Annex 5: Customer declaration HW change description v1.2 to Test Report 20-1-0017101T04a-C1

**Hardware change description
SICK LOCU1xx – UWB TAG**

v1r3 -> v1r3.1 change description

Details for changes of LOCU Battery Basic/Advanced bottom layer:

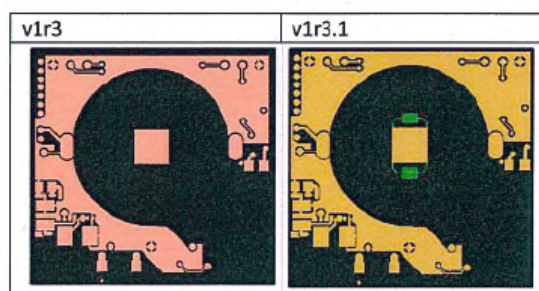
1. Battery holder: Pad adjustment of negative battery contact- milled grooves for battery holder are shifted in v1r3.1 comparing to v1r3. The pitch of grooves is increased by 0,45 mm.

- red mark - v1r3
- green mark - v1r3.1
